UNITED STATES PATENT AND TRADEMARK OFFICE

APPLICATION NO.	FILING DATE	FIRST NAMED INVENTOR	ATTORNEY DOCKET NO.	CONFIRMATION NO.
10/529,046	03/24/2005	Rolf Kordon	2002P01314WOUS	1779

Office Action Summary

DETAILED ACTION

Janke et al '4,920,758' Figure 5'

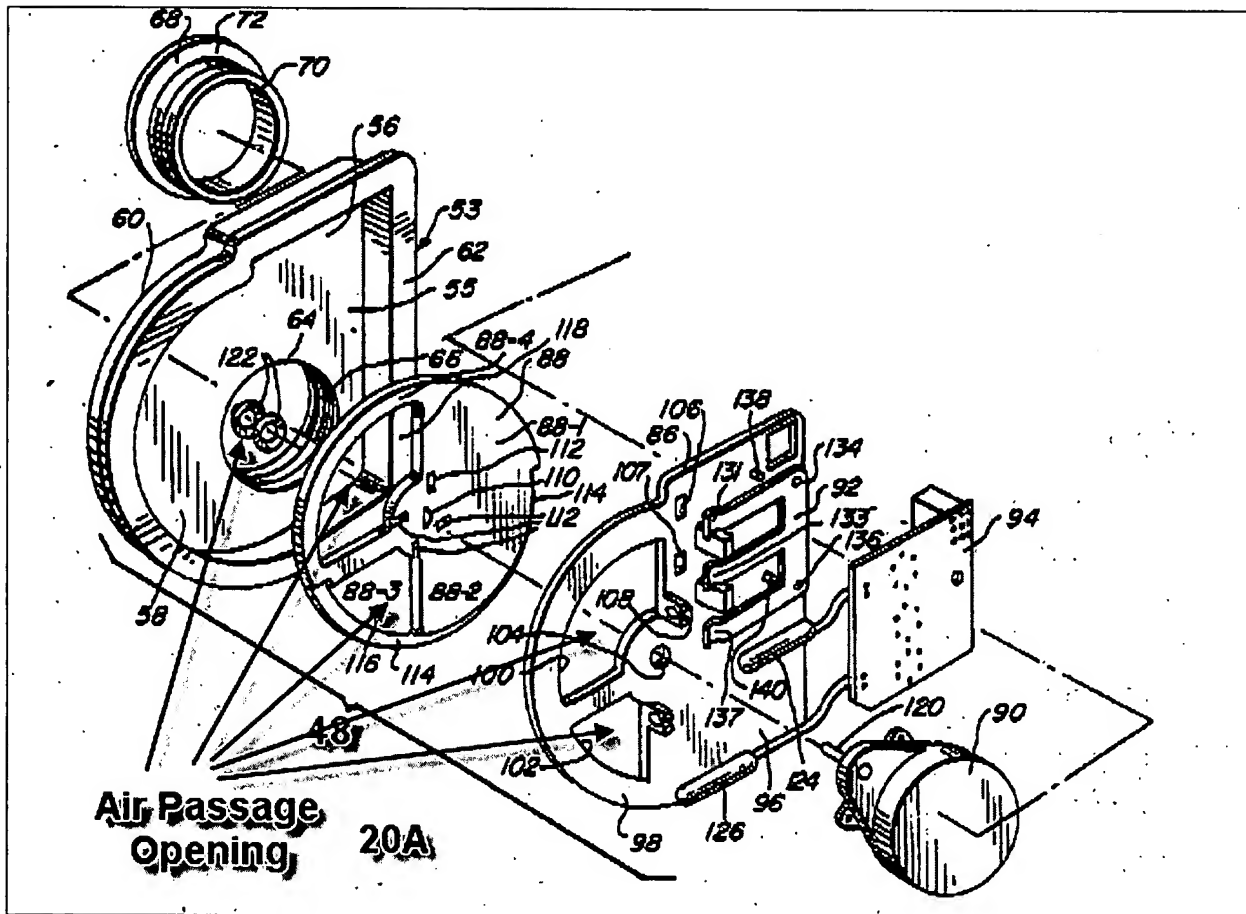
In re claim 15, Janke et al '758 discloses a storage chamber (22, figure 1); an evaporation chamber (20, figure 1); an air passageway (20A, figure 5') having a plane and enabling air exchange between said storage chamber (22, figure 1) and said evaporation chamber (20, figure 1); said air passageway (20A, figure 5') having an air

passage opening (**20A, figure 5'**) having a cross-section; a control body (88, figure 5) arranged on said air passage opening (**20A, figure 5'**); said control body (88, figure 5) shiftable between positions (column 6, lines 46-50) in which said control body (88, figure 5) variously covers said cross-section of said air passage opening (**20A, figure 5'**); and said control body (88, figure 5) rotatable about an axis substantially perpendicular to said air passageway plane. Please note that the freezer compartment is being identified as evaporation chamber since air sent through evaporator passes through fan aperture (28) and stored in this compartment.

In re claim 16, Janke et al '758 discloses invention above and further discloses a partition (18, figure 1) formed between said storage chamber (22, figure 1) and said

evaporation chamber (20, figure 1) and said air passageway (**20A, figure 5'**) is formed through said partition (18).

In re claim 21, Janke et al '758 discloses invention above and further discloses a support (68, figure 5) formed on said air passage opening (**20A, figure 5'**), said support having convex upwardly walls (66, figure 5) above said shaft (120). Please note that "coupling member" (68, figure 5) is a sleeve that threads into circular aperture (64). Please further note that inside wall of insert threaded sleeve is considered "convex upwardly walls" as required in claim limitation. (See column 4, lines 65-68 through column 5, lines 1-3 to further detail correlation)

In re claim 28, Janke et al '758 discloses invention above and further discloses a support (**21A, figure 5'**) formed on said air passage opening (**20A, figure 5'**) facing said control body (88, figure 5).

Oike '4,852,361' Figure 3

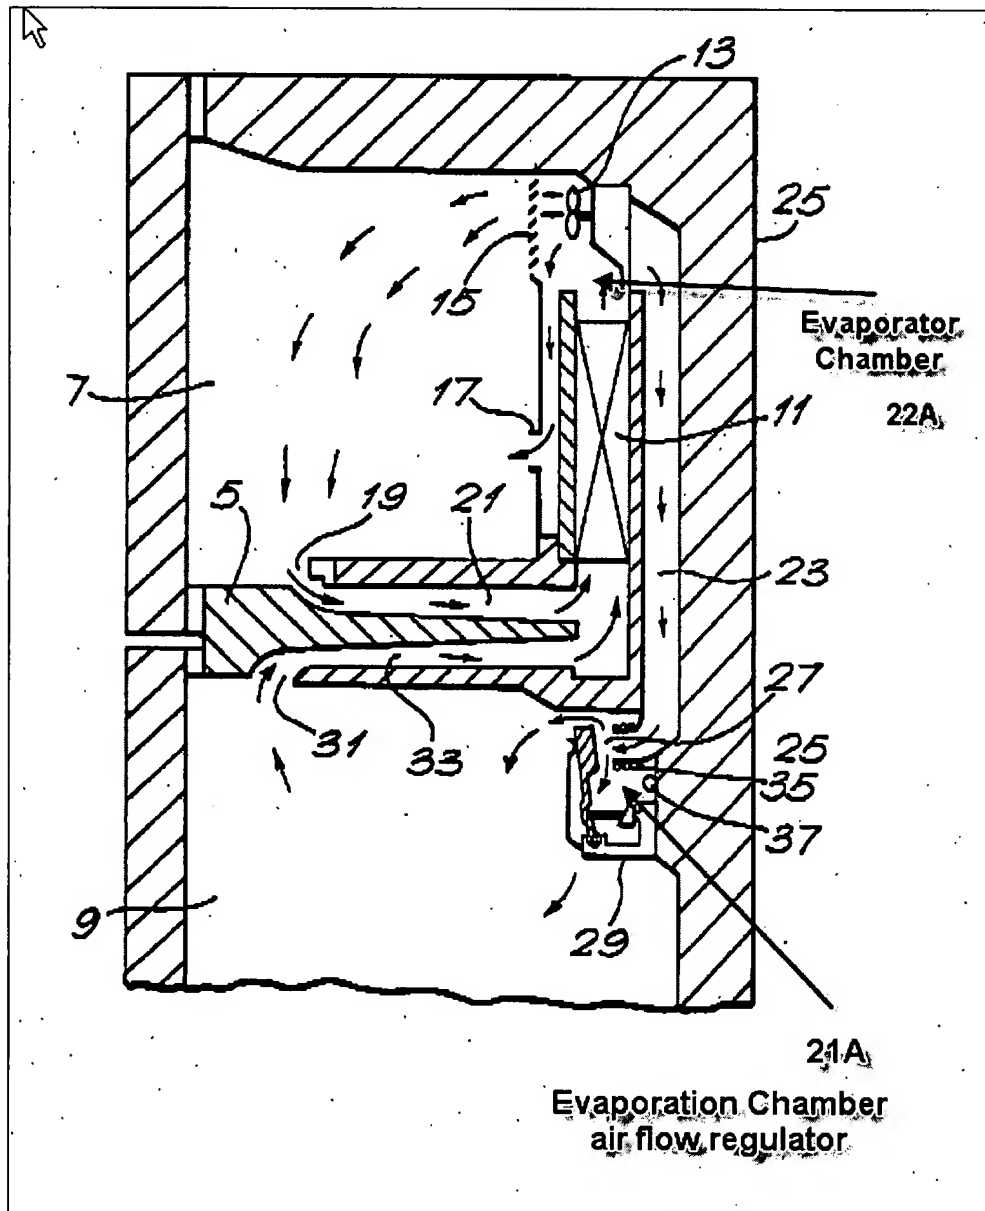
As an alternative to rejection statement above using Janke '758 (see figure 1) representation of an "evaporation chamber" (20, freezer section), Oike '361 discloses in figure 3 below an airflow regulator (21A, figure 3) operating between a storage chamber (9, figure 3) and an evaporation chamber (22A, figure 3).

It would have been obvious to one of ordinary skill in the art at the time of the invention was made to modify Janke et al '758 by placing evaporation chamber air-flow regulator directly in contact with evaporation chamber resulting in cooling the space

Nevertheless, Oike '361 teaches use of heating element (35) attached to a periphery of said cylindrical shell element (53, 86, figure 5). (Please see figure 3 above)

Ross '2,914,364' Figures 5 and 6, respectively

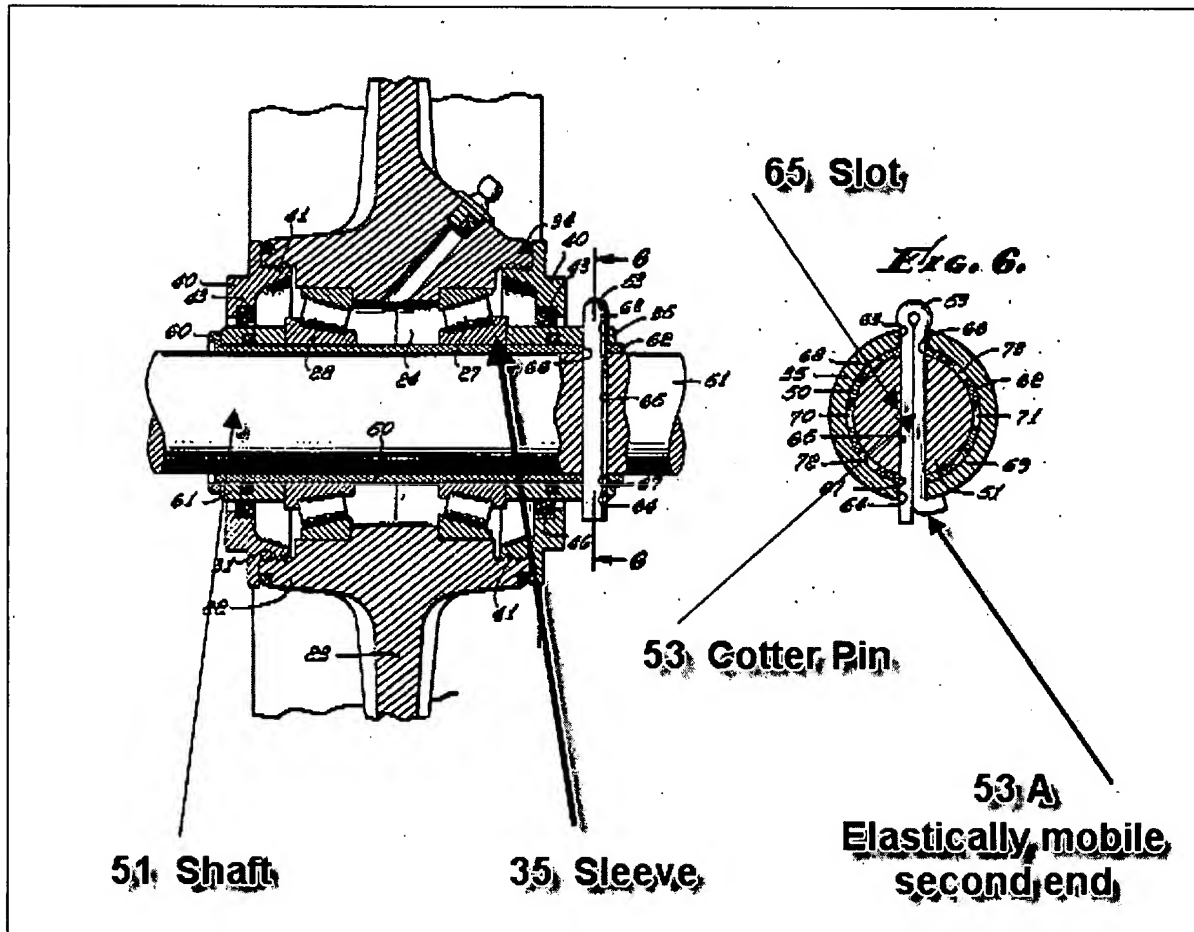
Nevertheless, Ross '364 discloses said shaft (51) and said sleeve (35) each have a slot (65) formed therein in a plane oriented diagonally to said axis and a locking element (53) is engaged in said slots (65) to lock said shaft (51) and said control body (Janke '758, 88, figure 5) together.

It would have been obvious to one of ordinary skill in the art at the time of the invention was made to modify Janke et al '758 by using slots and locking elements as outlined in figures 5 and 6 above would be to provide secure and easily removable securing system lending itself well to easy repair and thereby lowering repair costs.

In re claim 23, Janke et al '758 discloses invention above, however, fails to disclose said locking element having a first end fixedly secured in said control body and said locking element having an elastically mobile second end, said elastically mobile second end can be displaced to displace said locking element from at least one of said slots. Nevertheless, Ross '364 discloses said locking element (53) having a first end fixedly secured in said control body (Janke '758, 88, figure 5) and said locking element (53) having an elastically mobile second end (53A), said elastically mobile second end (53A) can be displaced to displace said locking element (53) from at least one of said slots (65).
